To: T10 Technical Committee  
From: Tim Hoglund (Tim.Hoglund@lsil.com)  
Date: 06 September 2003  
Subject: T10/03-311r0 BackoffRetry priority for XL state machine

### **Overview**

**Figure 1: Livelock condition due to re-arbitration**

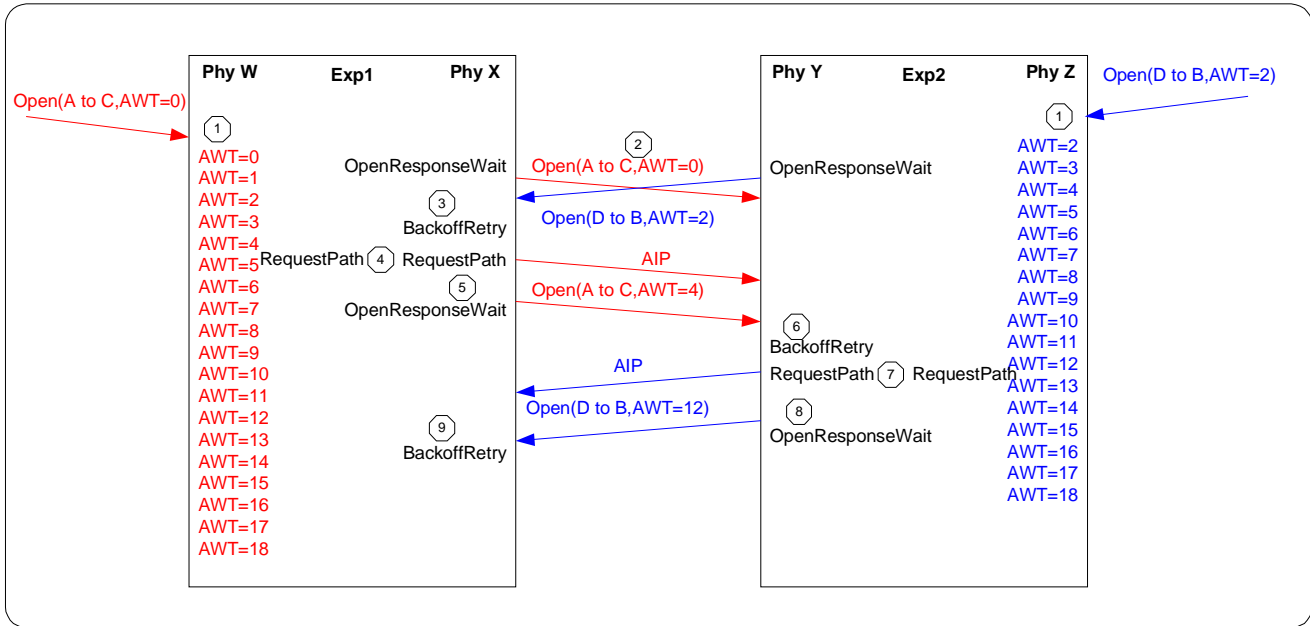
A potential livelock condition exists when OPEN address frames cross on a wire between two expanders. Because each source phy maintains (continues to increment) the AWT timer, the priority of a path request following the Backoff Retry condition may be elevated improperly. This can cause the ECM to select the wrong winner during arbitration, leading to a potential livelock condition.

Figure 1 illustrates a livelock case due to the re-arbitration that occurs after a Backoff and Retry condition.

1. Exp1[W] receives **Open (A to C, AWT=0)**. Exp2[Z] receives **Open(D to B, AWT=2)**.
2. Exp1[W] and Exp2[Z] both win arbitration and forward their Open address frame with the current AWT value to the other expander.
3. Exp1[X] receives a higher priority Open address frame and proceeds to XL1:Request\_Path to rearbitrate on behalf of this new Open address frame.
4. Exp1[W] and Exp1[X] arbitrate and Exp1[W] wins because AWT has continued to increment at Exp1[W].
5. Exp1[W] forwards **Open(A to C, AWT=4)** through Exp1[X] to Exp2[Y].
6. Exp2[Y] receives a higher priority Open address frame and proceeds to XL1:Request\_Path to rearbitrate.
7. Exp2[Y] and Exp2[Z] arbitrate and Exp2[Z] wins because AWT has continued to increment at Exp2[Z].
8. Exp2[Z] forwards **Open(D to B, AWT=12)** through Exp2[Y] to Exp1[X].
9. LIVELOCK...

A solution is provided which adds an additional argument to the Request Path request (expander phy to ECM connection request) in order to instruct the ECM to modify the arbitration priority for the path request for the phy which initiated the Backoff Retry condition.

Each path request contains the Arbitration Wait Time, Source SAS Address, and Connection Rate arguments from the received OPEN address frame.

Each path request also contains a Retry Priority status argument. The Retry Priority status argument is used to prevent Arbitration Wait Time from being considered during the arbitration which occurs after a BackoffRetry response is sent by an expander phy (see 7.15.4).

An expander phy shall set the path request Retry Priority status argument to RETRY PRIORITY IGNORE AWT when it requests a path after it has forwarded an OPEN address frame to a physical link and an OPEN address frame is received with higher arbitration priority and the destination SAS address and connection rate of the received OPEN address frame are not equal to the source SAS address and connection rate of the transmitted OPEN address frame (see 7.15.4 and 7.15.9); otherwise the Retry Priority status argument shall be set to RETRY PRIORITY NORMAL.
